10 June 2002
(R83-HEV-Rev 4)

**PROPOSAL FOR AMENDMENTS
TO THE 05 SERIES OF AMENDMENTS TO REGULATION No. 83**

Prescriptions concerning type-approval of hybrid vehicles

Transmitted by the expert from France

Condition A of the Type I test

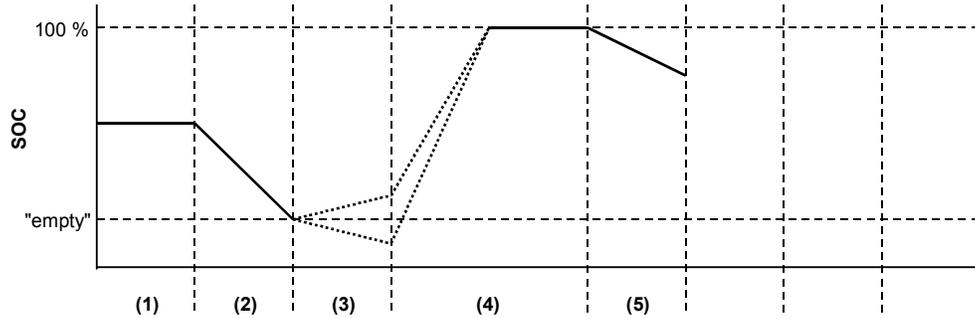
- (1) initial electrical energy/power storage device state of charge
- (2) discharge according to 3.1.2.1 or 3.2.2.1
- (3) vehicle conditioning according to 3.1.2.2 or 3.2.2.2
- (4) charge during soak according to 3.1.2.3 and 3.1.2.4 or 3.2.2.3 and 3.2.2.4
- (5) test according to 3.1.2.5 or 3.2.2.5

Condition B of the Type I test

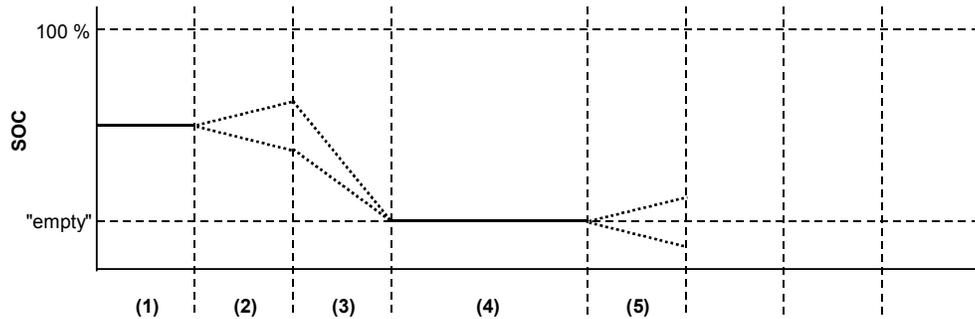
- (1) initial state of charge
- (2) vehicle conditioning according to 3.1.3.1 or 3.2.3.1
- (3) discharge according to 3.1.3.2 or 3.2.3.2
- (4) soak according to 3.1.3.3 or 3.2.3.3
- (5) test according to 3.1.3.4 or 3.2.3.4
